South Buckinghamshire Area Planning Committee agenda

Report to South Buckinghamshire Area Planning Committee

Application Number:	PL/20/1718/DE
Proposal:	Reserved matters approval pursuant to planning permission Ref 17/01763/OUT for Phases 1 and 2, comprising 147 dwellings, open space, landscaping, access within the site and car parking (matters of access within the site, appearance, landscaping, layout and scale to be considered).
Site Location:	Defence School of Languages, Wilton Park, Gorell Road, Beaconsfield, Buckinghamshire, HP9 2RP
Applicant:	Inland Homes Limited
Case Officer:	Mr Graham Mansfield
Ward affected:	Gerrards Cross
Parish Town Council:	Beaconsfield Town Council
Valid date:	24 July 2020
Determination date:	23 December 2020
Recommendation:	Defer and delegate the application to the Director of Planning and Environment to Approve reserved matters subject to the conditions set out in this report and the satisfactory completion of a Legal Agreement to secure a SAMMs payment for the Burnham Beeches Special Area of Conservation or to refuse if a satisfactory Legal Agreement cannot be completed for the appropriate reasons relating to the impacts on Burnham Beeches Special

Extract 1:

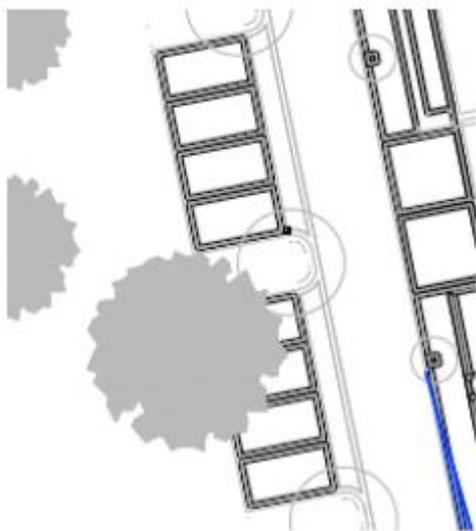
Within the submitted amended plans, dated October 2020, visibility splays of 2.4m x 25m have now been shown on the northern and eastern cycle streets alone. All other junctions within the development show visibility splays measured with an 'x' distance of 2m.

The applicant states that the 'y' distance of the visibility splays is based on the SSD of 25m, which is commensurate with the proposed 20mph speed limit. The drawing shows that the 'y' distance has been measured along the delineated roadside edge and assumed position of a vehicle at junction squares. Paragraph 4.2.4 of the TS states that "There are two locations where the y distances are not achieved. Both locations are on the approach to junction squares. Not providing the full visibility splay in these locations will force drivers to approach the junction squares with more caution, providing a benefit to those residents walking and cycling in the area". While I do not necessarily agree with what the applicant is stating here, I am mindful of the type of streets, the environment where these visibility splays are being proposed and the likely low speeds of vehicles as they approach the junctions. As stated previously in this response, while the visibility splays at some of the junctions may not achieve a standard that the Highway Authority would recommend on the public highway, the site is to remain in private ownership and as such we do not feel that this is something, as a Highway Authority, we are able to pursue.

Parking spaces positioned adjacent to the perimeter roads, like those in the extract above, did not previously benefit from adequate visibility due to the margin to the front of the spaces not being wide enough to allow a car to pull forward to see along the carriageway without the visibility being restricted by the cars parked in the adjacent spaces.

Extract 2:

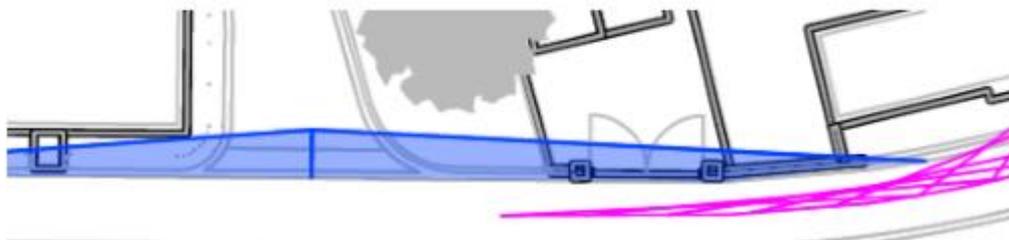
Extract 2 above shows an access between two buildings. The buildings were previously right on the edge of the carriageway, therefore the visibility at this junction was greatly restricted by the buildings. The need to assess visibility at this junction has been raised previously with the applicant, however no assessment appears to have taken place. It is evident on the revised plans that these buildings have been moved back from the carriageway edge and while there remains not assessment of the visibility at this junction in the submitted information I have measured the visibility on the latest plans and I can confirm that the amendments have improved visibility at this junction.

Extract 5:

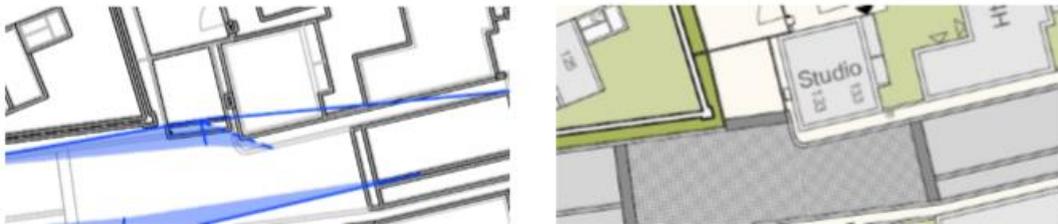
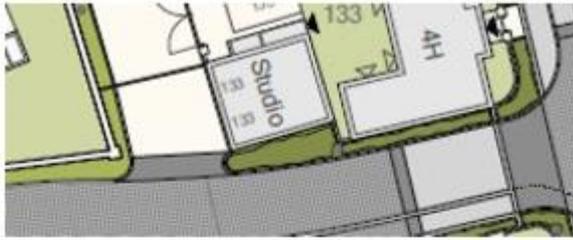
In order to make the visibility issues shown in the Extract 5 above (which is taken from the original information) clearer I have also included an extract from the Masterplan. It is clear to see from the extract above that the visibility from the northern arm of this junction was severely restricted by the building to the east. In addition, the building to the east of the junction is shown to be a Studio, and the information submitted with the application suggests that the studios have garages beneath them. The positions of the number '133' on the extract above would appear to show where the parking spaces are within the garage. This suggested that they are accessed from the main carriageway to the south and if this the case then there will be very little visibility for vehicles exiting the garages. In addition to the visibility along the main carriageway being restricted, there would have been very little intervisibility between a vehicle turning to the east out of this arm of the junction and a vehicle exiting the garages.

Following these concerns, the applicant has now rotated the position of the Studio which has improved the level of available visibility at this junction, achieving a 'y' distance of approximately 18m. In addition, the rotation has now meant that vehicles within the garage exit out onto the quieter street and not onto the main carriageway which is a safety improvement. The amendments are confirmed by the extract below.

Extract 7:

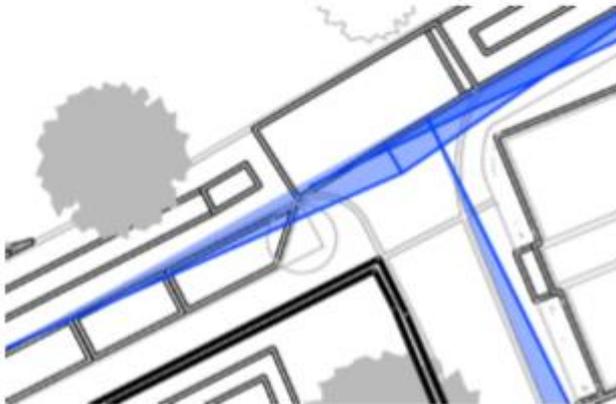
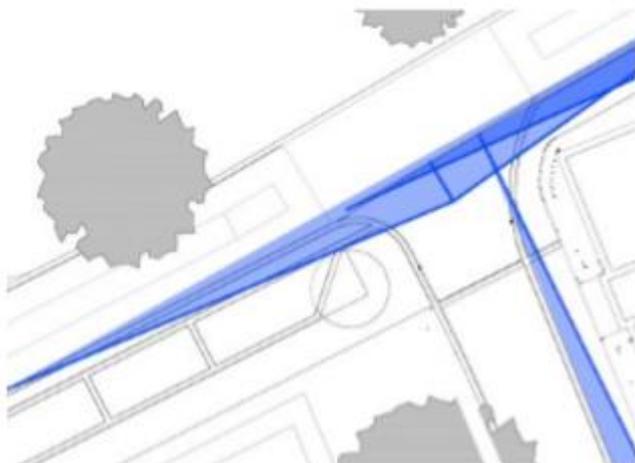
The visibility splay to the south west of the junction shown in the extract above (which is taken from the original information) passes through the parking spaces. It was therefore likely that the splay will be obstructed by cars parked in the spaces and cannot therefore be guaranteed. However, within the amended plans, these parking bays have now been set further back from the carriageway edge. As a result, full 2.4m x 25m visibility splays can be achieved in both directions from this junction without obstruction. This is confirmed by the extract below.

Extract 9:

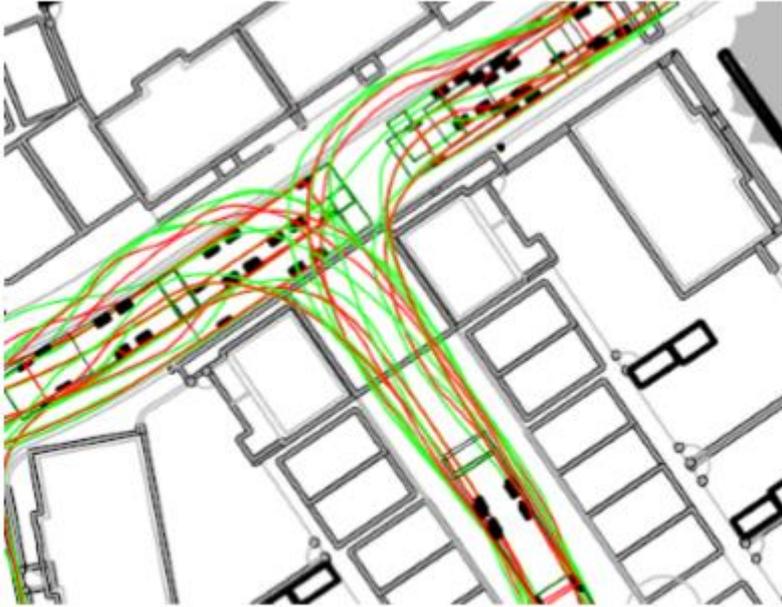
There are locations within the site where the swept path of larger vehicles passes very close to buildings which leave very little margin for error in order to avoid conflict. The example shown in Extract 9 above is also of one of the junctions where the applicant was requested to assess the visibility. As confirmed earlier in this response, the applicant has positioned the buildings either side of the access further back away from the carriageway edge, which has not only improved visibility but has improved the manoeuvring space for vehicles turning through the junction.
